Re: 2-6 Market Street – Special Permit – Site Plan

**City of Newburyport Planning Board
Review for Compliance with Site Plan Review Regulations**

Review of Special Permit and Site Plan Applications for 2-6 Market Street Mixed Use Project November 8, 2019

A1.0

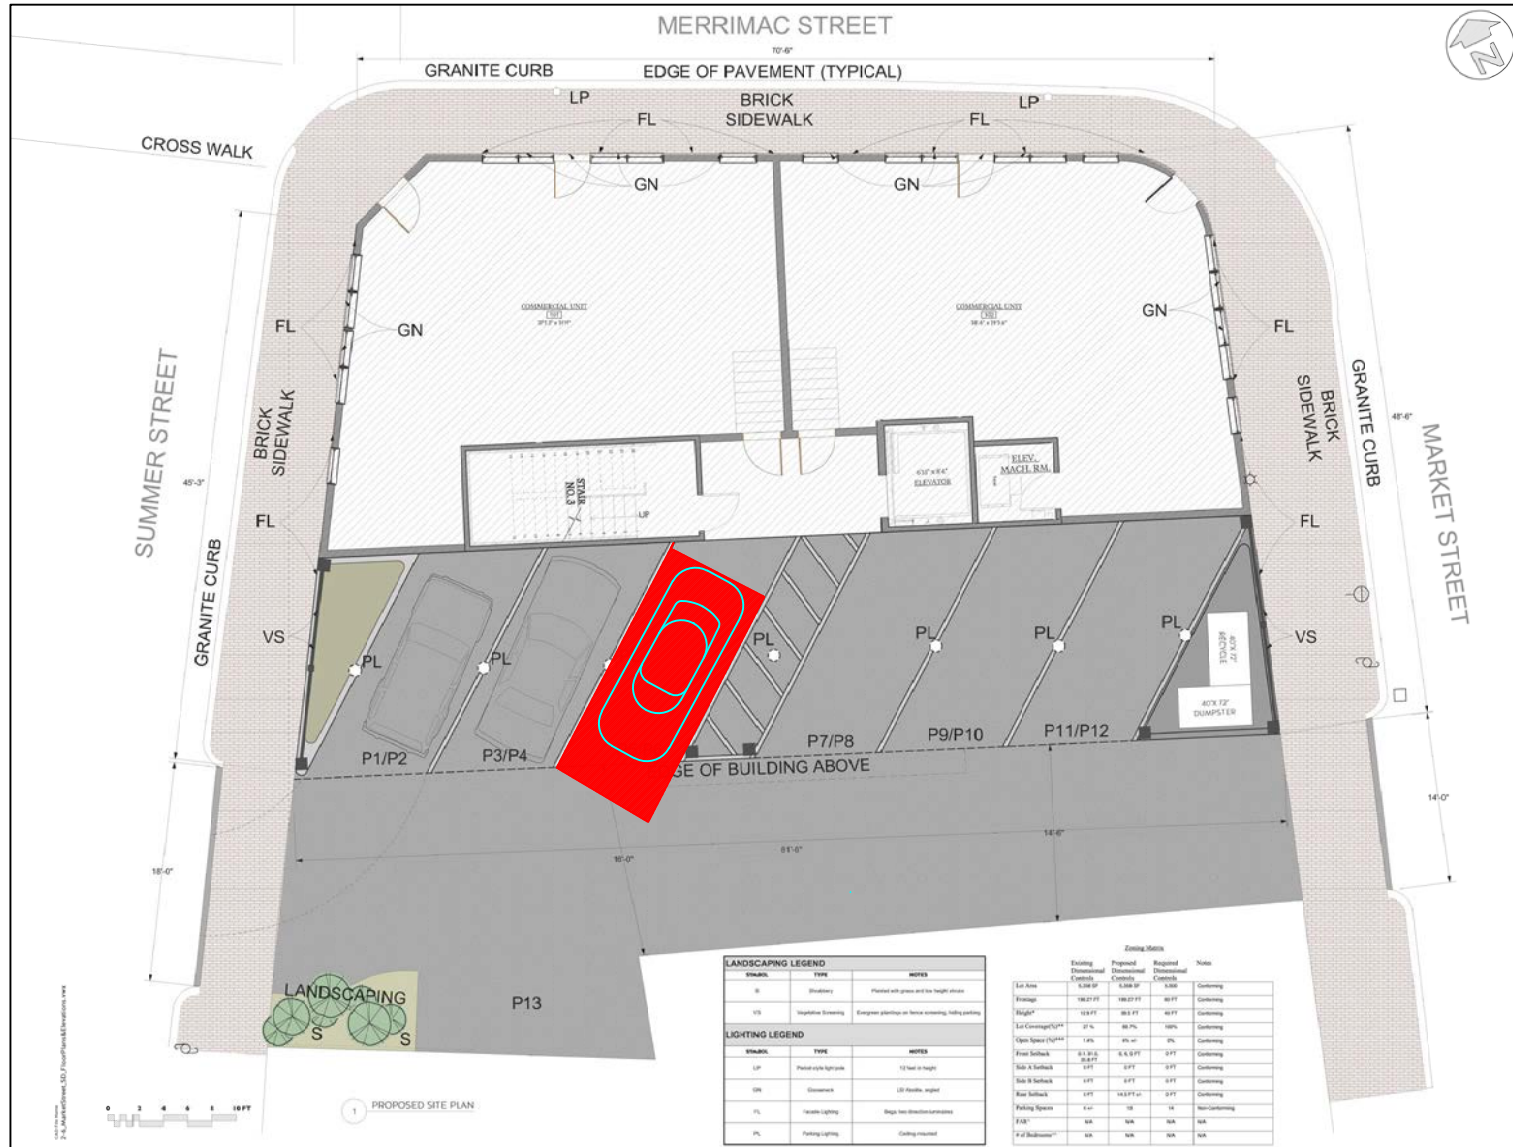
The text submitted suggests 12 off street parking spaces yet the drawing on page 15 has 13 spaces labeled. The Rear Elevation on Page 13 shows stacked parking for 12 cars. The cars are perpendicular to the proposed building and the elevation doesn't show the dumpster and recycle bin location at the southeasterly corner of the building nor the landscaped area on the southwesterly side of the building as shown on A1.0. The proposed site plan on page 15 and

A1.0 shows 12 parking spaces but angled rather than perpendicular to the building and the dumpster area and landscaped area are shown.

The perpendicular parking would not work because of the limited turnaround area in the easterly end of the driveway. The stacked parking may not work with the angled arrangement if the dimensions shown in the figure on page 16 for the length of the lifting unit is 19 feet 3 inches and has to be placed six inches from a wall. The corner of the lift would protrude into the driveway as shown in the attached pdf where the area taken up by the lift is shown in red superimposed on the plan A1.0.
